Changes V4 to V5 Per ECR E1400164 and T1400223:  
 R10 & R15 from 10k to 2.2k  
 R5 & R23 from 3.9k to 2.0k

Title		
<b>UIM Circuit Pre-production model</b>		
Size	Number	Revision
C	<b>D070481</b>	V5
Date:	9/2/2015	Sheet 2 of 2
File:	C:\Rob's Files\UIM\Circuit_V5.SchDoc1 Drawn By: R.M.Cutter

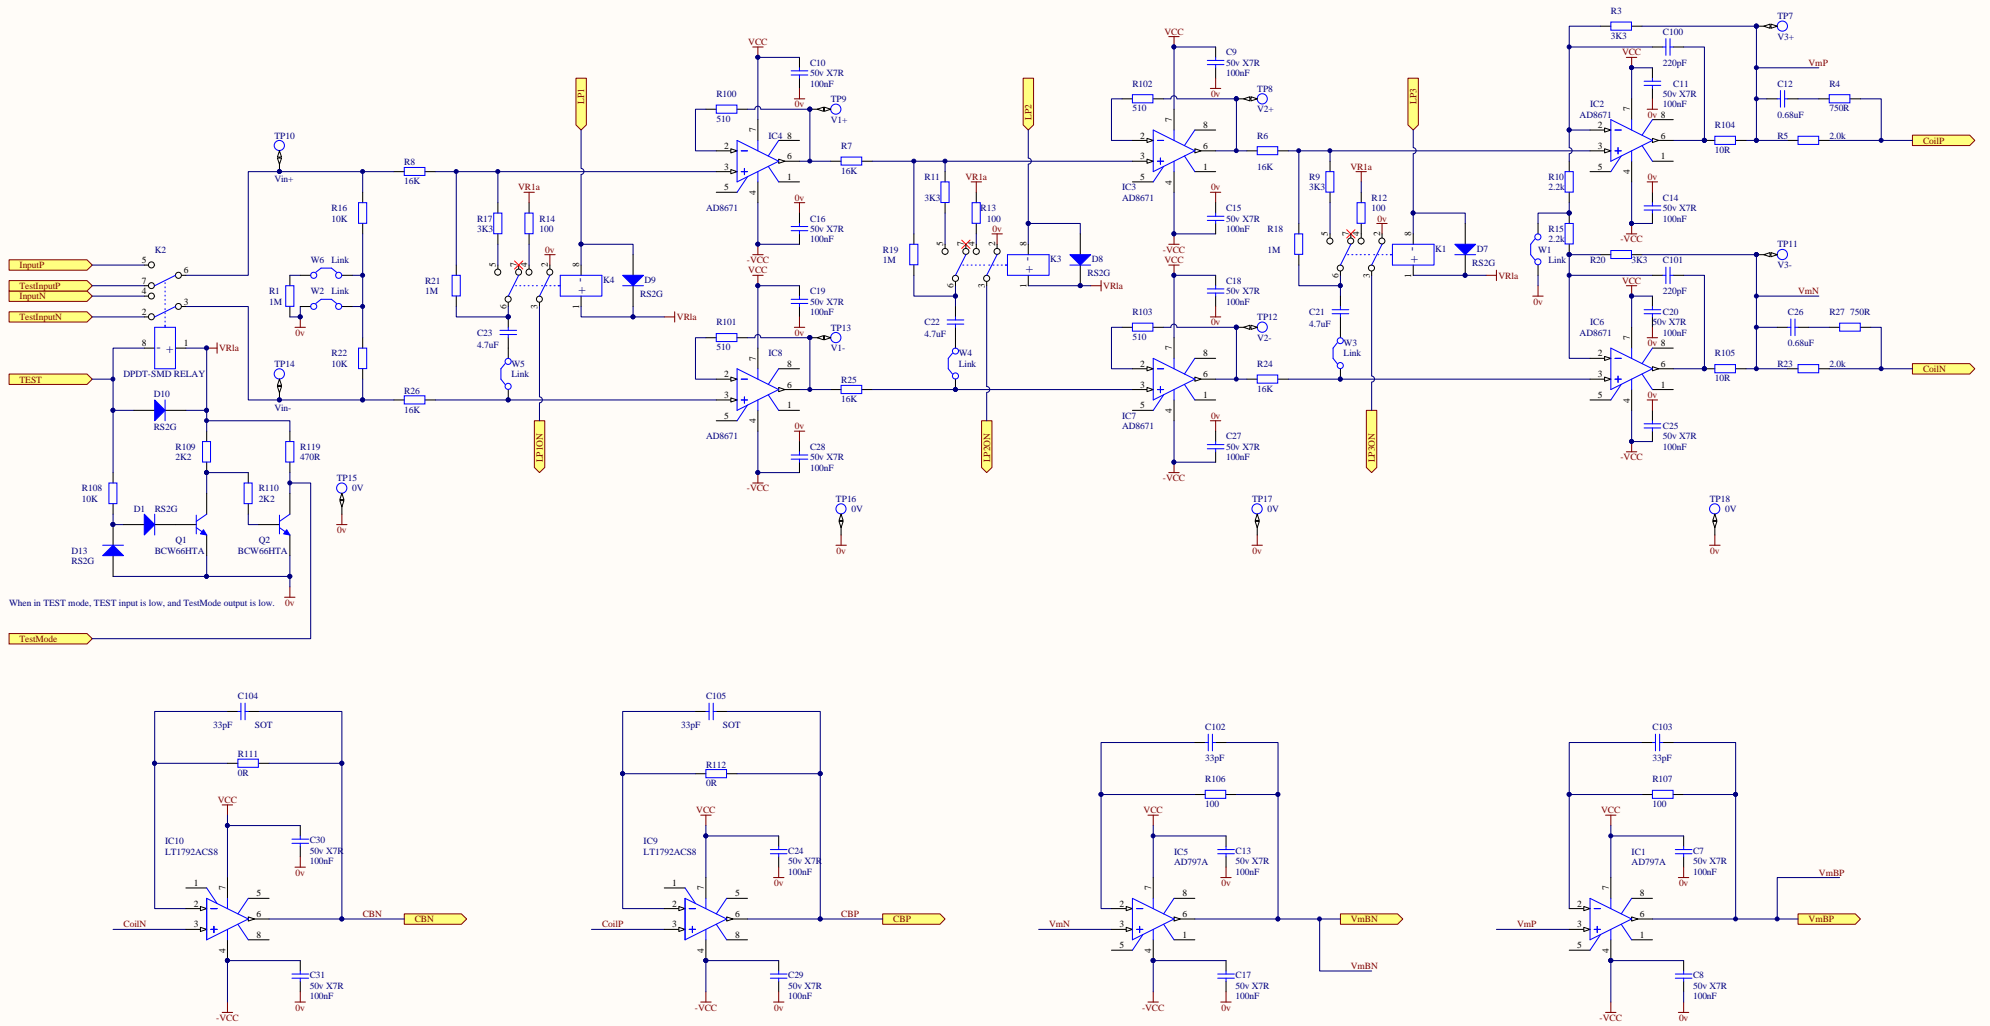
These changes were by a desire for more actuation dynamic range.

The bill of materials has been updated to reflect these part value changes, but the actual part numbers is not known. The parts are all 1206 surface mount resistors, and hopefully thin film components were used.
